The Horsley Dr Business Park Stage 2
SIDRA Modelling Review Comments

The Horsley Drive / Cowpasture Rd Roundabout: (2016 AM Existing) & (2016 PM Existing)

The Horsley Drive / Cowpasture Rd RMS Upgrade: (2026 AM Base) & (2026 PM Base)

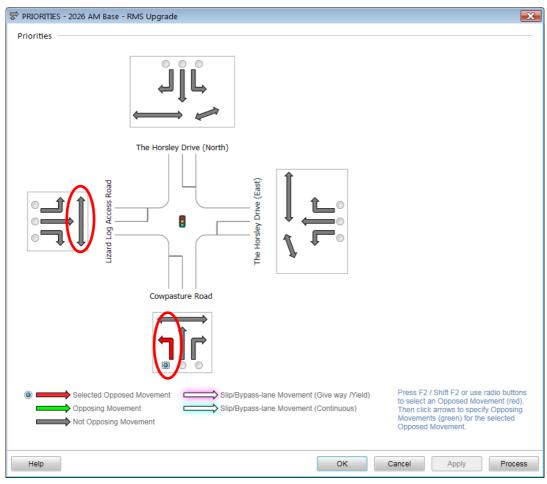
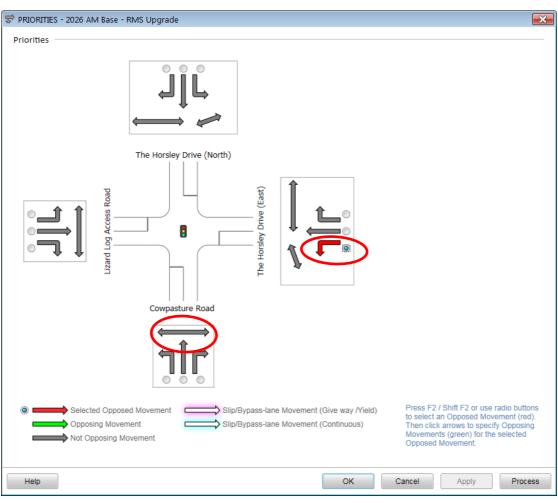
- Lane lengths could not be verified due to absence of data.
- Phasing adopted in the model seems to be unusual. Needs to be verified with Network ops team to confirm phasing and cycle time adopted in the model is accurate.

- It is noted that ped volume adopted for this scenario in the model is 1. It is accepted that no ped volume are currently available to use in the model. it is however recommended to use more realistic volume of peds in the model.
- Current phasing adopted in the model has error under priorities. Pedestrian movements have not been specified as opposing movements for left turning movements. See below:

The Horsley Drive / Cowpasture Rd Signals: (2016 AM Base) & (2016 PM Base)

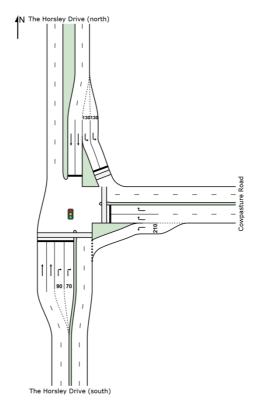
- Lane length on Southern approach should be approx.160m instead of 180m.
- Lane length on Eastern approach should be approx.200m instead of 300m.
- Lane 4 on Southern approach should be approx. 90m and lane no 3 should 70m.
- Lane no 4 on Northern approach should be approx. 100m instead of 130m.

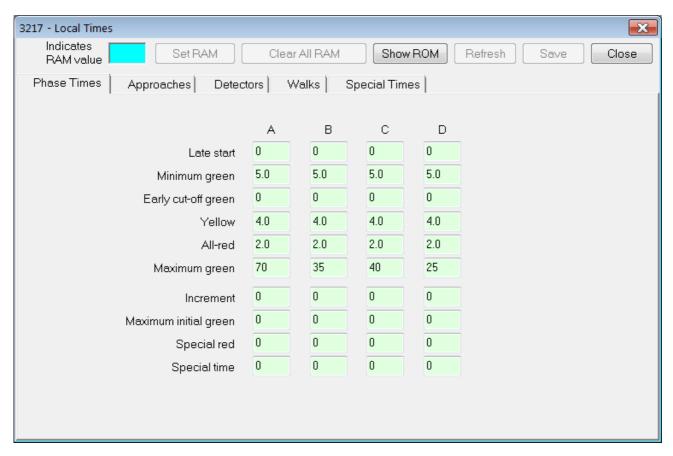
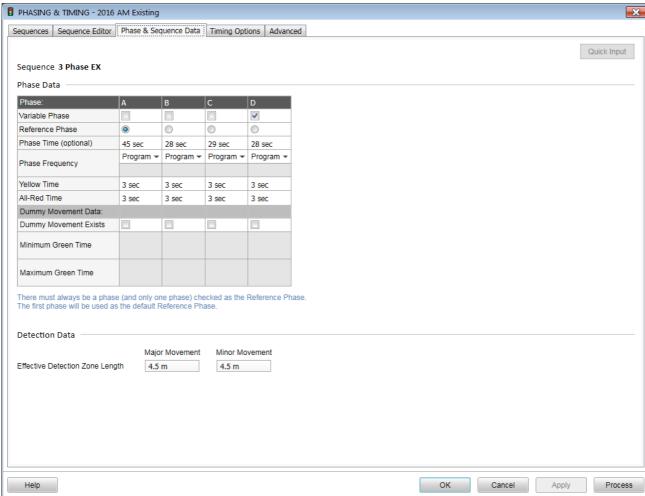
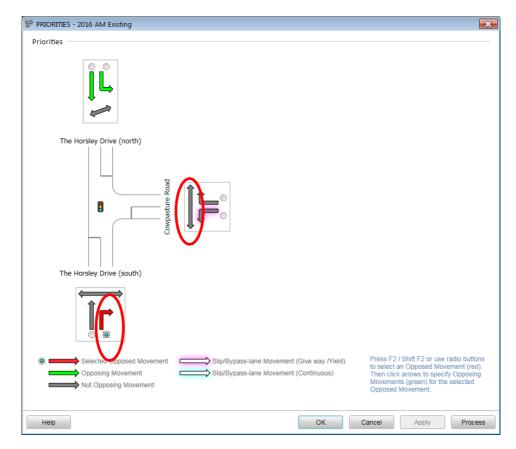
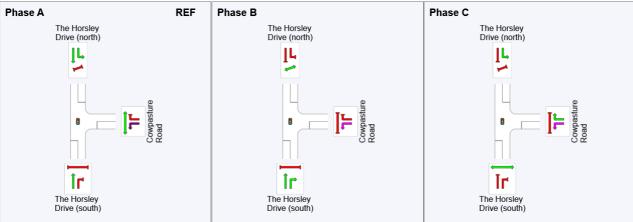
- More conservative pedestrian volume should have been adopted in the model for this assessment instead of just 1.
- It is noted that Optimum cycle time option has been adopted this scenario. Justification should be given to use this option. User given cycle time option should have been used for the intersection analysis.
- Need to verify the cycle time for this intersection with Network Ops. SIDRA has adopted 105sec cycle time.
- SCATS seem to indicate the yellow phase time of 2 sec and red phase time of 2 sec for all phases. Yellow and red phase times of 3 sec for all phases seem to have been used in the model. This is incorrect. See below

• Current phasing adopted in the model has error under priorities. Pedestrian movements have not been specified as opposing movements for left turning movements. See below:

Cowpasture Rd / Newton Rd Roundabout: (2016 AM Base) & (2016 PM Base)

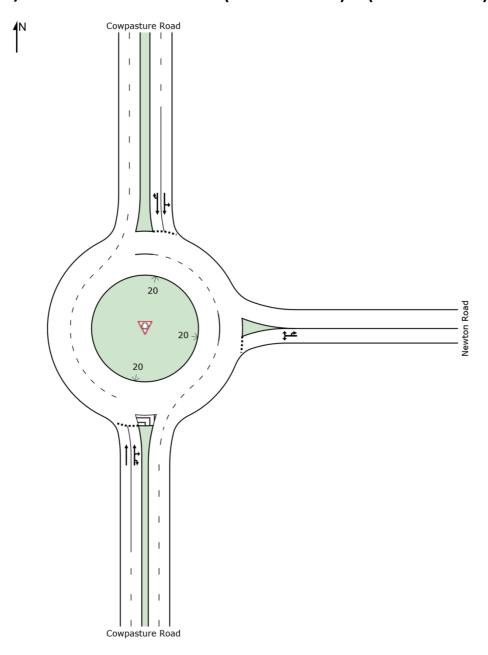
- Lane length on Southern approach should be approx.200m instead of 500m.
- There should be three exit lanes on southern approach instead of two.

Cowpasture Rd / Stage 1 Access Rd Roundabout: (2016 AM Base) & (2016 PM Base)

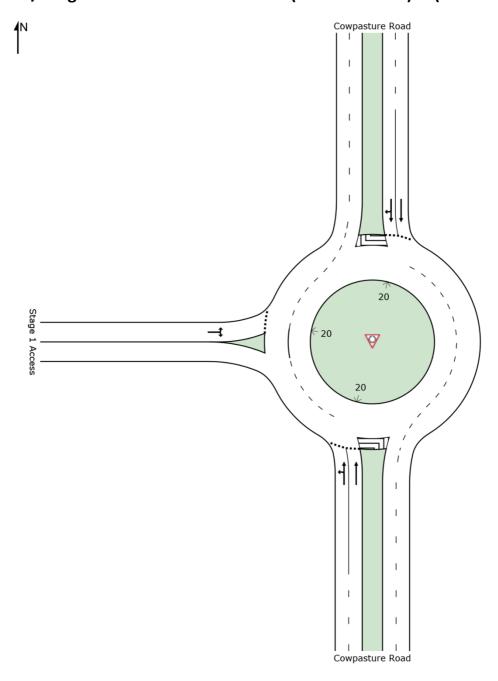
- Lane length on Southern approach should be approx.130m instead of 500m.
- Lane length on Northern approach should be approx.330m instead of 500m.
- Lane length on Western approach should be approx.260m instead of 500m.
- Approach and exit cruise speed on Western Approach should be less than 60km/h.

Cowpasture Rd / Victoria St Roundabout: (2016 AM Base) & (2016 PM Base)

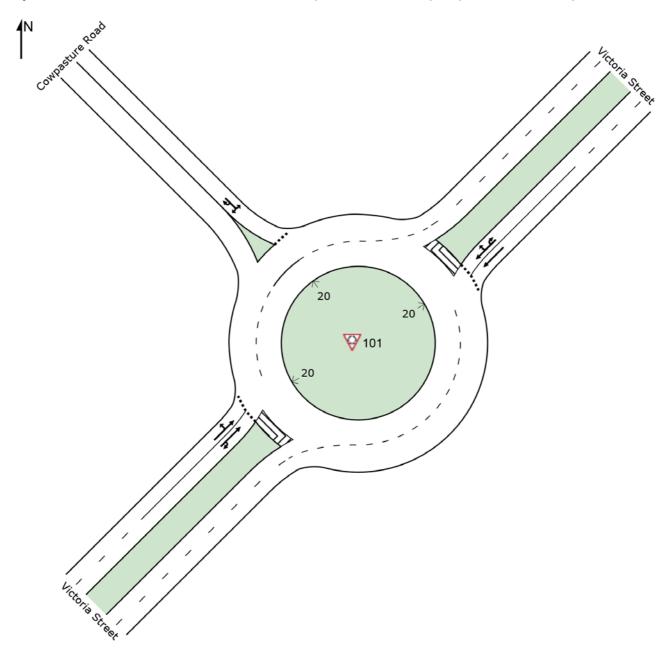
• Lane length on Southern approach should be approx.330m instead of 500m.

Cowpasture Rd / Stage 2 Access Rd Roundabout: (2016 AM Base) & (2016 PM Base)

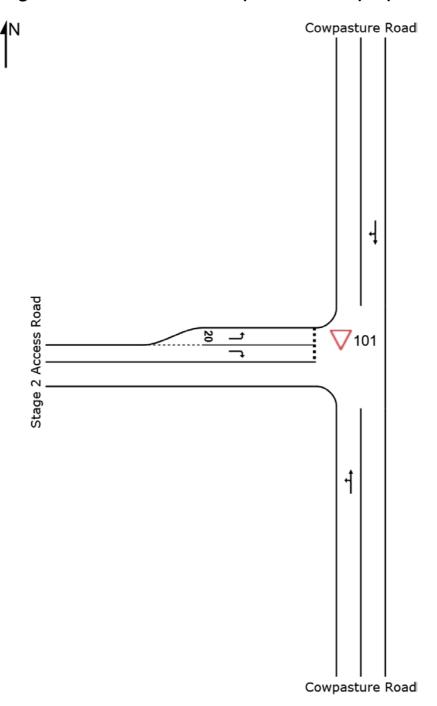
- Lane length on Southern approach should be less than 500m. Couldn't verify exact length due to lack of data.
- Lane length on Northern approach should be less than 500m. Couldn't verify exact length due to lack of
- Consideration should be given to construct either separate right turning bay of appropriate length or BAR type passing lane on Northern approach.
- Through lane length on Western approach should be less than 500m. Couldn't verify exact length due to lack of data.
- Approach and exit cruise speed on Western Approach should be less than 60km/h.

Cowpasture Rd / Trivet St: (2016 AM Base) & (2016 PM Base)

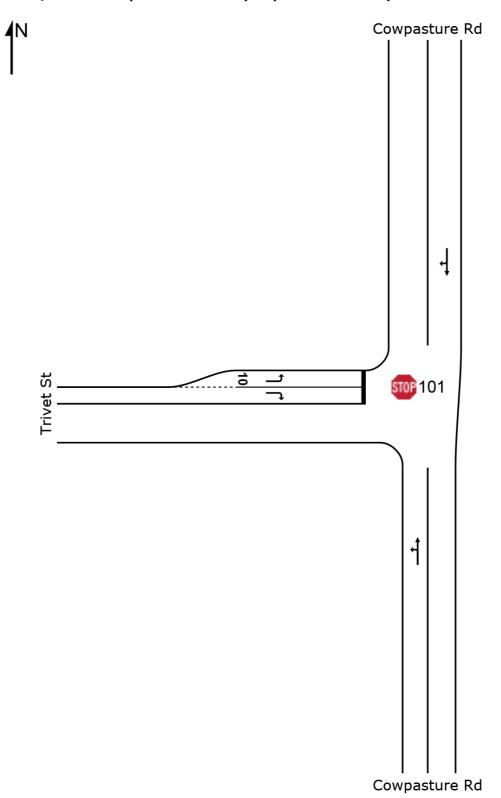
• Lane length on Southern approach should be approx.276m instead of 500m.

The Horsley Dr / Ferrers Rd Signals: (2016 AM Base) & (2016 PM Base)

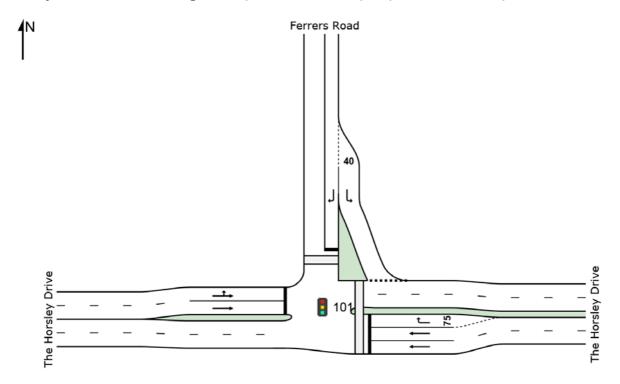
- More conservative pedestrian volume should have been adopted in the model for this assessment instead of just 2.
- It is noted that Optimum cycle time option has been adopted this scenario. Justification should be given to use this option. User given cycle time option should have been used for the intersection analysis.
- Need to verify the cycle time for this intersection with Network Ops. SIDRA has adopted 80sec cycle time.
- Current phasing adopted in the model has error under priorities. Pedestrian movements have not been specified as opposing movements for left turning movements. See below:

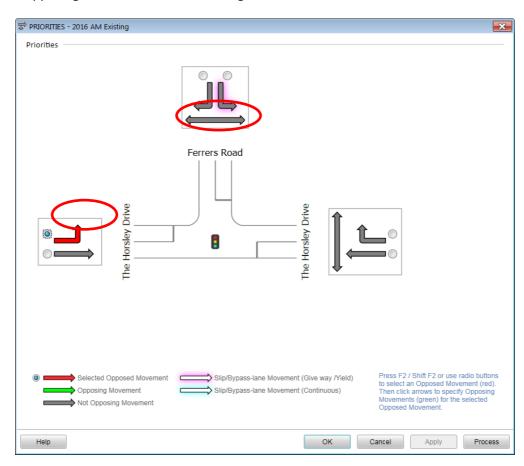
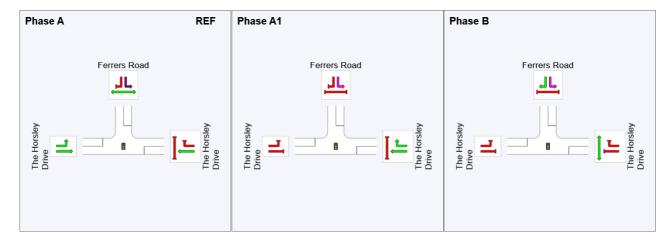
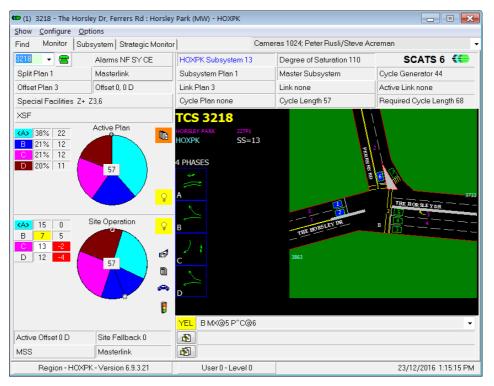
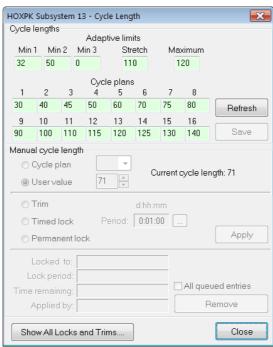
Phasing adopted in the model appears to be different than what shown by SCATS. TCS at this site operates
with four phases and max cycle time of 120 sec. See below:
